DOCKETED	
Docket Number:	21-IEPR-01
Project Title:	General Scope
TN #:	241324
Document Title:	Electrochaea Corporation Comments - on Draft 2021 Integrated Energy Policy Report, Vol III Decarbonizing the State's Gas System
Description:	N/A
Filer:	System
Organization:	Electrochaea Corporation
Submitter Role:	Public
Submission Date:	1/28/2022 2:45:41 PM
Docketed Date:	1/28/2022

**Comments on Draft 2021 Integrated Energy Policy Report, Vol III
Decarbonizing the State's Gas System**

Re: Docket No. 21-IEPR-01
Draft 2021 Integrated Energy Policy Report, Vol. III: Decarbonizing the State’s Gas System

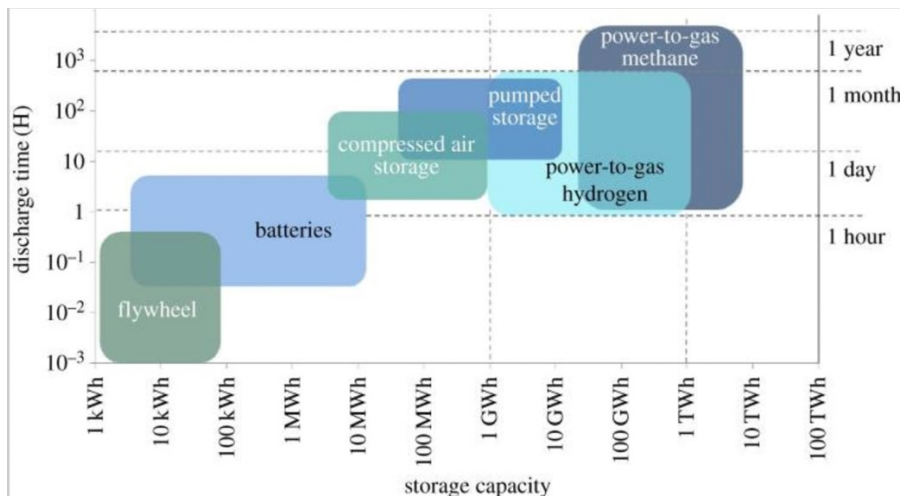
- a. *An addition is requested on page 59 regarding methanation as relevant to renewable gas generation*

The section entitled Converting Biogas to Renewable Gas beginning on page 59, describes the process in which the methane is separated from the other components of biogas; biogas is typically 60% methane and 40% CO₂. Methods that are currently used in the field result in the release of the CO₂ present in the biogas. In this section of the IERP, it should be mentioned that there is an industrial scale process that can be used to convert the CO₂ into renewable methane using a methanogenic microorganism and green hydrogen. This method can increase the production of renewable gas by 70-100%, while eliminating the release of climate-damaging CO₂, and instead recycling the carbon into a low-carbon intensity fuel. Methanation can be completed by a chemical catalyst in the Sabatier process³ or by a biological catalyst in the biomethanation process⁴. Both of these processes use the CO₂ in the production of methane instead of releasing it into the environment. When renewable electricity is used in the process, the resulting product is a renewable gas.
